# Historic Landmark Commission September 26, 2011 Permits in National Register Historic Districts NRD-2011-0079 West Austin Park – Shelter House 1317 W. 10th Street

CASE#: NRD-2011-0079

**SUBJECT:** Updated: Back-up information for National Register Permit:

**West Austin Shelter House Improvements**

Figure 7: Graffiti on West Austin Shelter House.

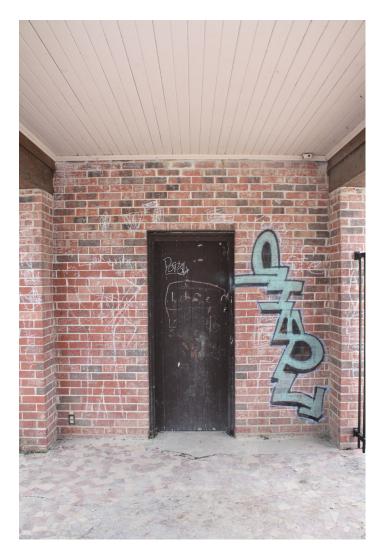
- a. The grant proposal calls for paining the entire interior and exterior of the building with no/low VOC paint: "Building includes 2 restrooms, storage room, area between the two bathrooms and entire exterior of structure." In clarifying with committee members, it was confirmed that only the wooden trim on the building would be repainted as the painting of exterior brick would not be permitted.
- b. Considerations: Graffiti removal is a challenging issue (Fig. 7). Removal of graffiti must be done carefully and no products can be used that are deleterious to the integrity of the brick and mortar. An excellent reference, *NPS Preservation Brief 38: Removing Graffiti from Historic Masonry*, is attached. (Appendix C).
